Office Action Summary	Application No. 10/583,862	Applicant(s) MACHIDA ET AL.	
	Examiner ALLAN R. WILSON	Art Unit 2815

DETAILED ACTION

FIG 10B

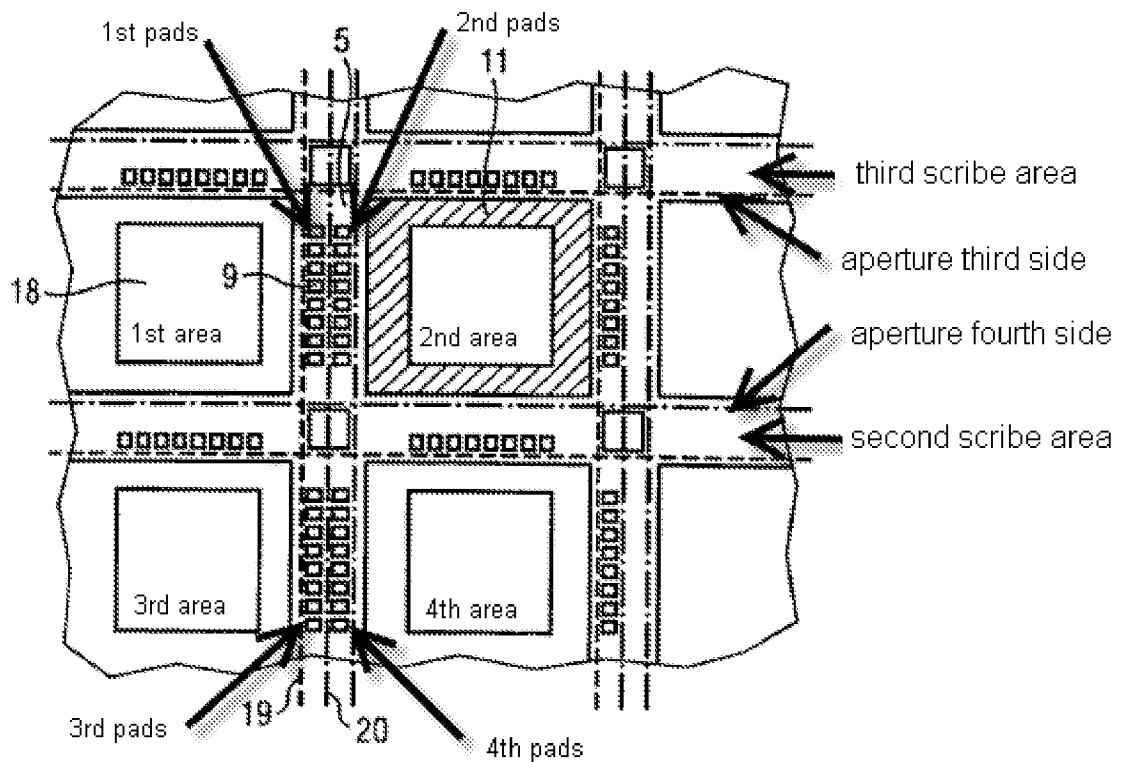
Regarding claim 2, Aigner illustrates in FIGs. 10A and 10B (see annotated FIG. 10B below) said first wafer has a second scribe area

said aperture 5 has a third side crossing said first side and said second side and a fourth side opposed to said third side,

the fourth side of said aperture is placed between said second scribe area, said first pad and said second pad, and

the third side of said aperture is arranged to be placed between said third scribe area, said first pad and said second pad.

Regarding claims 3 and 23, Aigner illustrates in FIGs. 10A and 10B (see annotated FIG. 10B above) said first wafer 1 has:

Regarding claims 4 and 24, Aigner illustrates in FIGs. 10A and 10B (see annotated FIG. 10B above) said aperture 5 has a third side crossing said first side and said second side and a fourth side opposed to said third side,

Regarding claims 8 and 10, Aigner illustrates in FIGs. 10A and 10B (see annotated FIG. 10B above) said first wafer further has second through fifth scribe areas,

Regarding claim 21, insofar as understood, Aigner illustrates in FIGs. 10A and 10B (see annotated FIG. 10B above) a substrate 1 having a first side (at 20), a second side (not shown - at scribe area on opposed side of first scribe area 20) opposed to said first side, a third side (at
